WELL API NO. 30-005-20098
5. Indicate Type of Lease STATE ☒ FEE ☐
6. State Oil & Gas Lease No.
7. Lease Name or Unit Agreement Name Cato San Andres Unit
8. Well Number #39
9. OGRID Number 248802
10. Pool name or Wildcat Cato; San Andres

Proposed P&A NOI
State of NM Orphan Well Program
Cato San Andres Unit #39
30-025-20098

**Cato San Andres Unit 39
BLM
March 25, 2025
Conditions of Approval**

Action 453196

State of NM Formerly Cano Petro of NM		PROPOSED	
Author:	Abby @ JMR	Well No.	#39
Well Name	Cato San Andres Unit	API #:	30-005-20098
Field/Pool	Cato; San Andres	Location:	Sec 8, T08S, R30E
County	Chaves		1980 FSL & 1980 FEL
State	NM	GL:	4069
Spud Date	7/15/1967

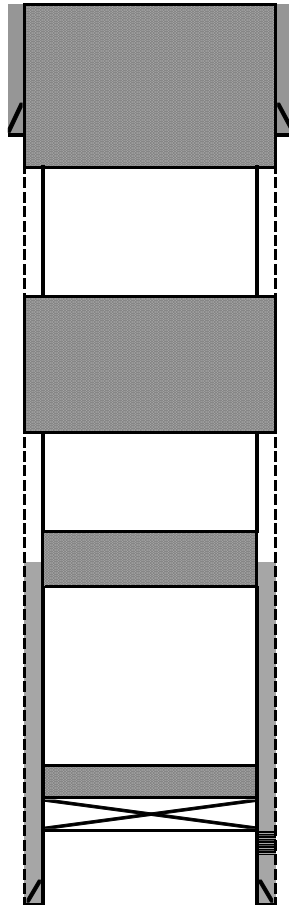
Plug #4: Perf & Sqz 247 sxs class C cmt @ 588' & circulate to surface.
(180 sxs outside, 67 sxs inside)

Plug #3: Perf & Sqz 393 sxs class C cmt w/ 2% CaCl @ 1,855-800'. WOC & Tag
(Yates, B/Salt, T/Salt, & Rust) (278 sxs outside, 115 sxs inside)

Plug #2: Spot 30 sxs class C cmt w/ 2% CaCl @ 2,208-1,972'. WOC & Tag (Grbg, Qn)

Plug #1: Set 5 1/2" CIBP @ 3,202'. Spot 91 sxs class C cmt w/ 2% CaCl @ 3,202-2,312'.
WOC & Tag. (San Andres)

1. Operator shall place CIBP at 3,152 ' (50'-100' above top most perf) and place a minimum of 25 sx of Class C cement on top. WOC and TAG.
2. Operator shall place a balanced Class C plug from 2,482' to 2,357' to seal the San Andres Formation.

3. Operator shall place a balanced Class C plug from 2,208' to 1,972' to seal the Grayburg and Queen Formations.
4. Operator shall perf at 1,855' and squeeze Class C cement to 1,305' seal the Yates and bottom of the Salt Formations. WOC and TAG.

5. Operator shall perf at 1,053' and squeeze Class C cement to 800' seal the top of Salt and Rustler Formations. WOC and TAG.
6. Operator shall perf at 588' and squeeze class c cement to surface to seal the 8-5/8" casing shoe.

7. Dry hole marker must be below ground.
8. Surface reclamation will need to be completed once the well bore has been plugged. Please contact rflores@blm.gov for additional information.
